V8 XJ Series/XK

303-S514

TECHNICAL BULLETIN

Operation Of Throttle While In Closed Position – Service Action S514

ILLUSTRATION 10

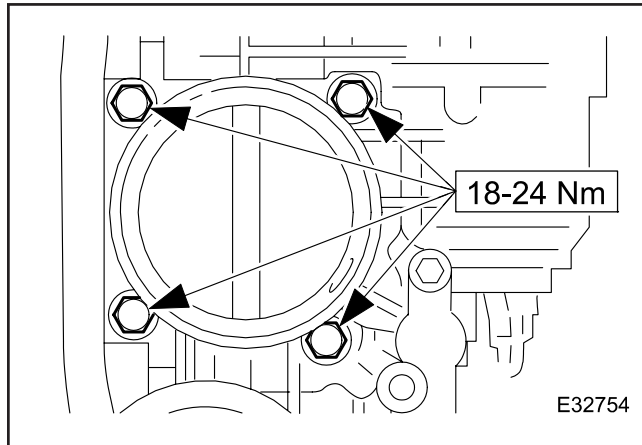
11. Install new throttle body gasket. Install new throttle body.

ILLUSTRATION 16

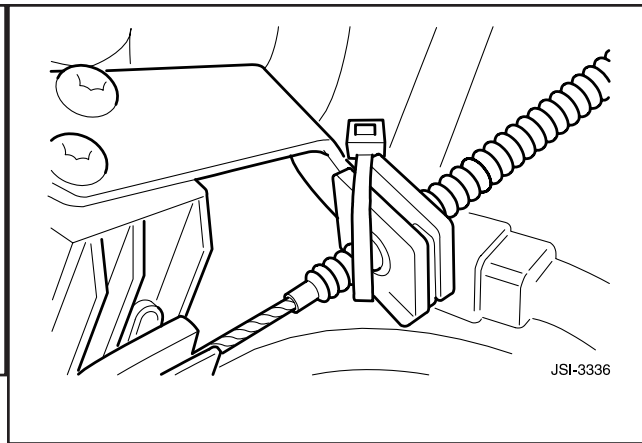
Remove and destroy Bulletin 303-S514, dated 08/04.
Replace with this Bulletin.
Revisions are marked with a bar and in **bold text**.
References to the tie strap for plastic adjustment nuts
have been added on page 10.

16. **⚠ WARNING: FOR VEHICLES WITH THE PLASTIC ADJUSTMENT NUT, AFTER CORRECT CABLE ADJUSTMENT, YOU MUST INSTALL A RATCHET TIE STRAP TO FULLY RETAIN THE ADJUSTER NUT IN ITS LOCATION WITHIN THE ABUTMENT BRACKET, (ILLUSTRATION 16) REFER TO RECALL ACTION R466.**
